Subject: Negative Declaration for the Proposed Hickam Golf Course:
12-Inch Nonpotable Water Main; Honolulu International Airport,
TMK:1-1-03, Honolulu, Oahu, Hawaii

**FINAL
ENVIRONMENTAL ASSESSMENT**

**HICKAM GOLF COURSE
NON-POTABLE: 12-INCH WATER MAIN
HONOLULU INTERNATIONAL AIRPORT**

**HICKAM GOLF COURSE
NON-POTABLE: 12-INCH WATER MAIN
HONOLULU INTERNATIONAL AIRPORT
Tax Map Key: 1-1-03**

GENERALIZED SUBSURFACE.
 CROSS SECTION A-A'
 (Looking East)

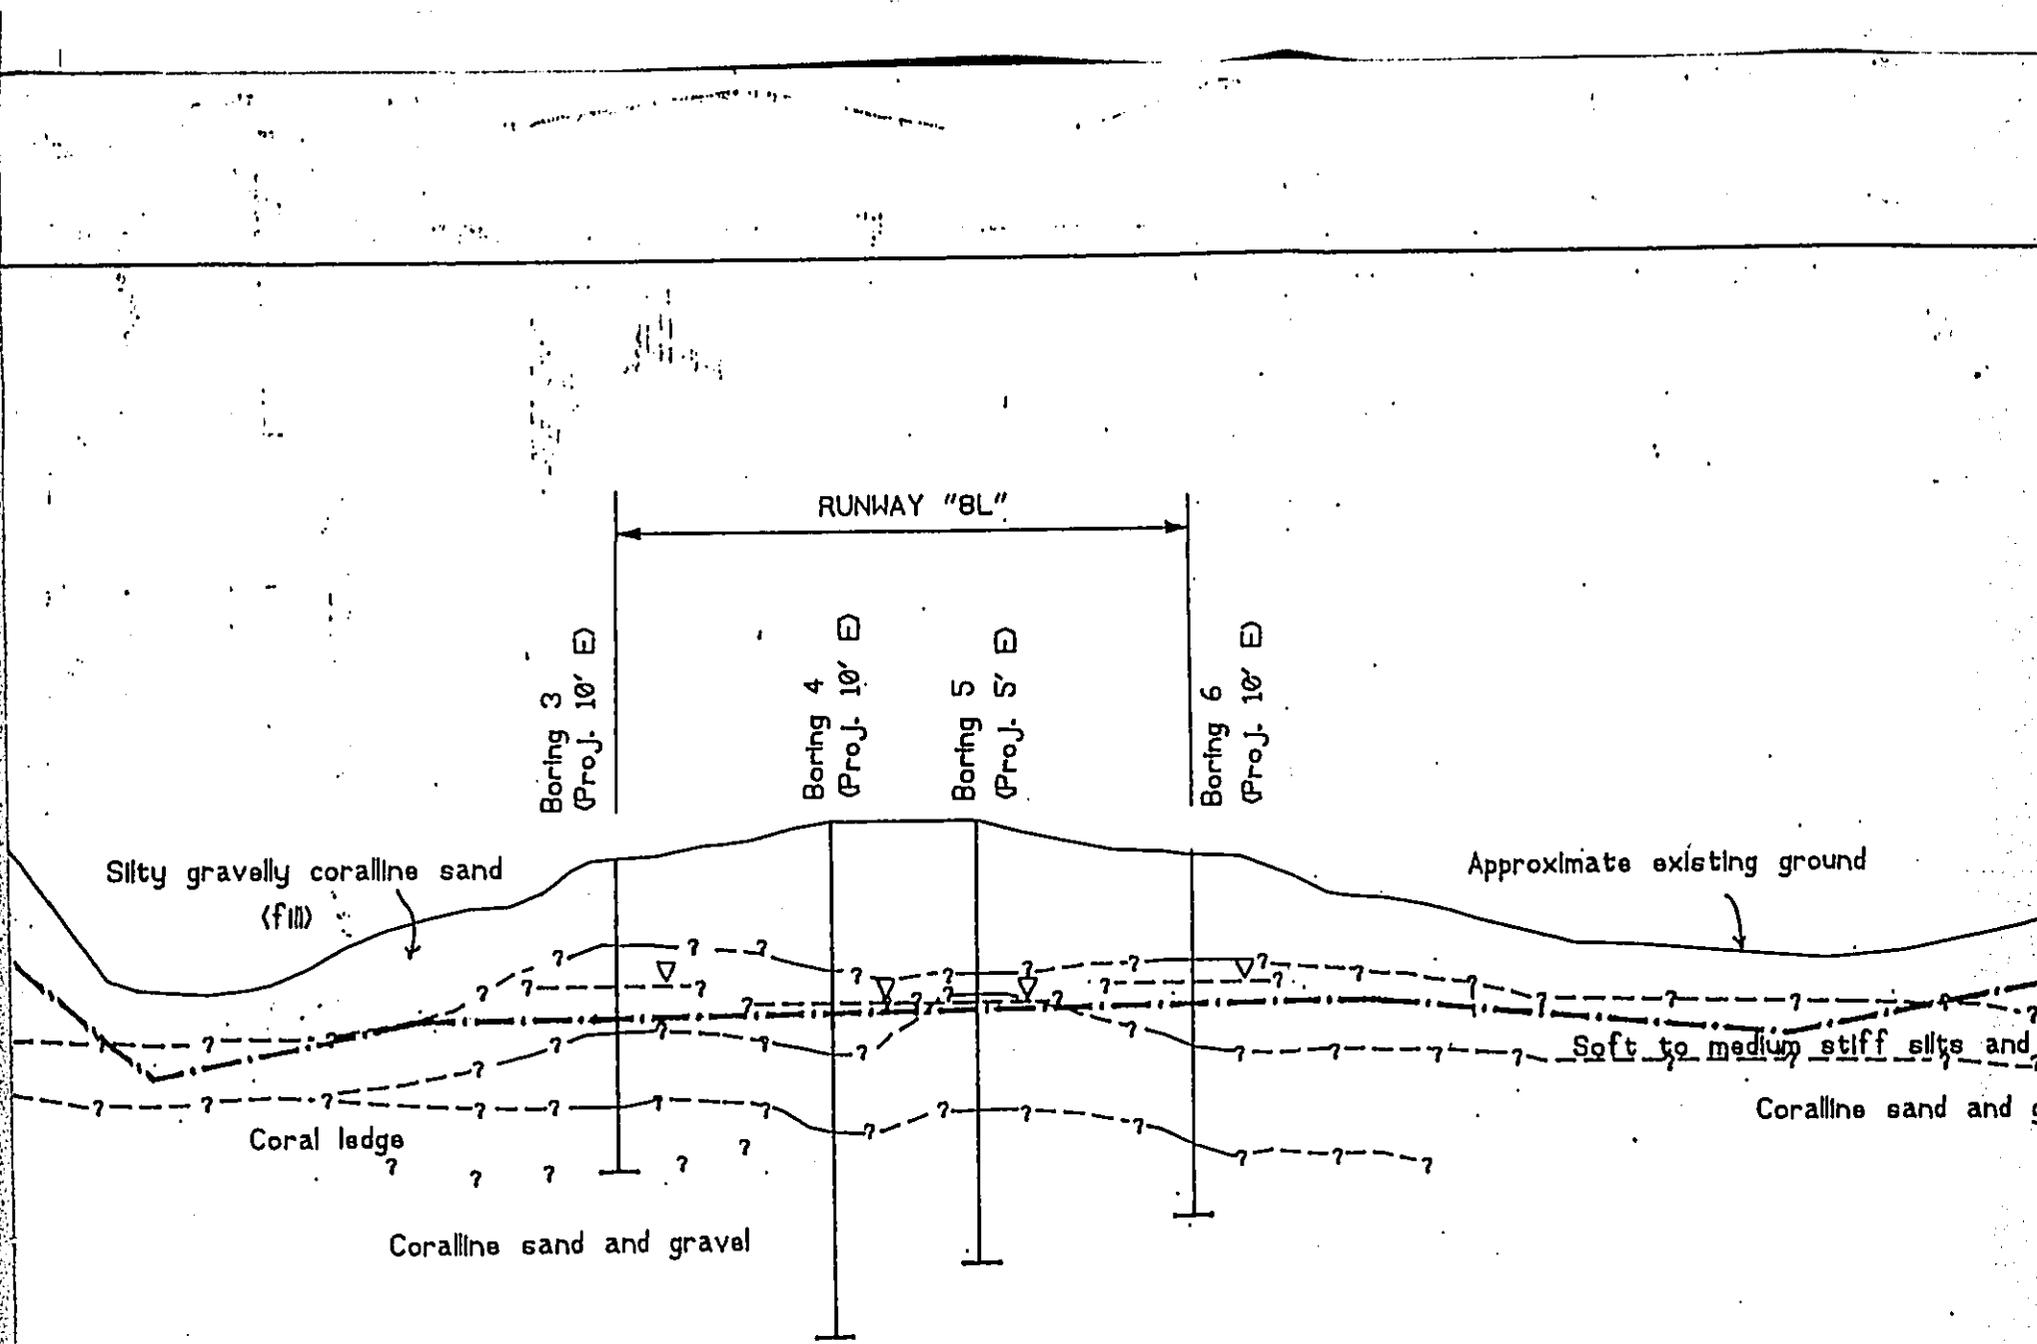
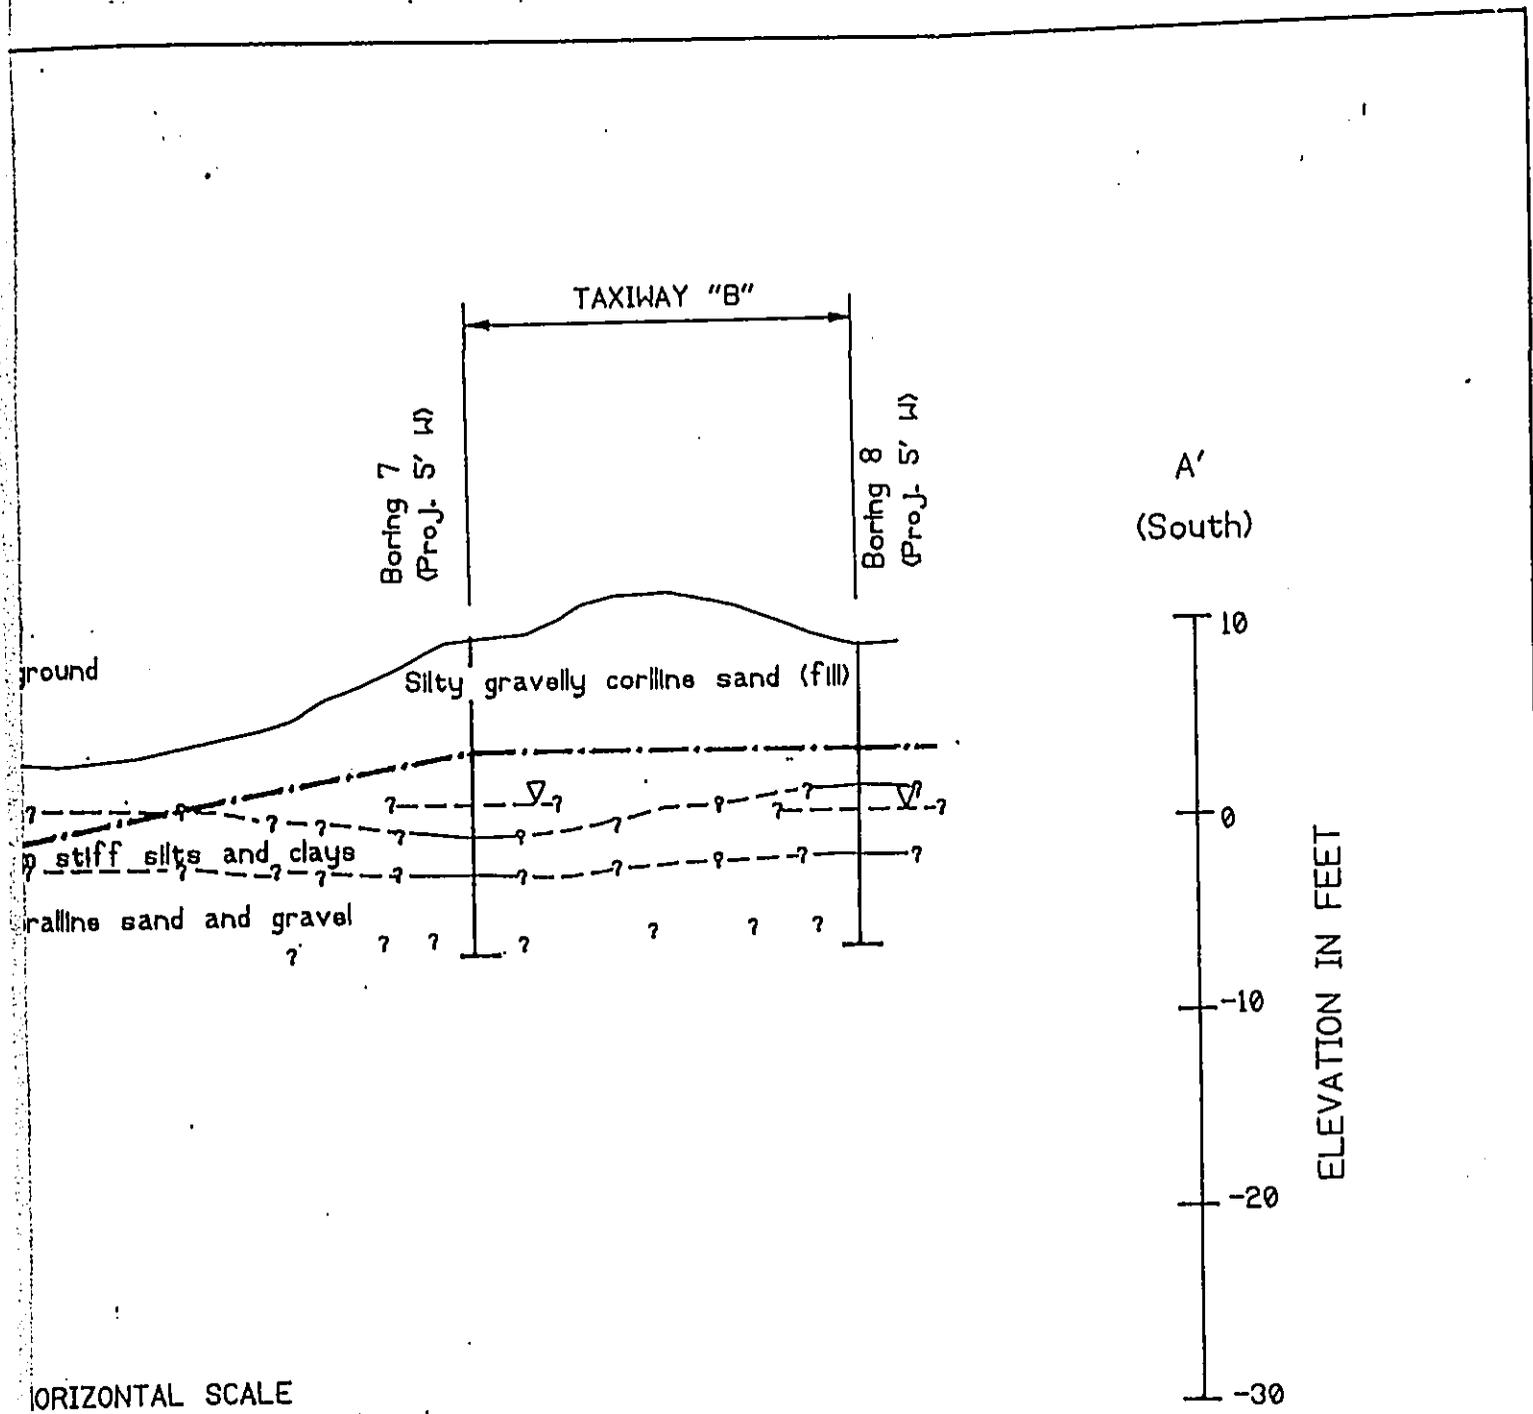
**SUBJECT: Revised Design, Hickam Golf Course Non-potable 12-inch Water
Main, Honolulu International Airport
Moanalua, Kona, O'ahu
TMK: 1-1-3**

In response to our June, 1995 letter to you (LOG NO: 14828), Jing Liang provided us with a revised Cross Section with proposed water line invert for this project. The revised cross section shows that the proposed depth of the waterline invert is now shallower than in the prefinal draft environmental assessment, and is at or above ground water level over its entire length.

Because fishpond sediments are located below the water table, we now believe the revised waterline invert will have "no effect" on historic sites.
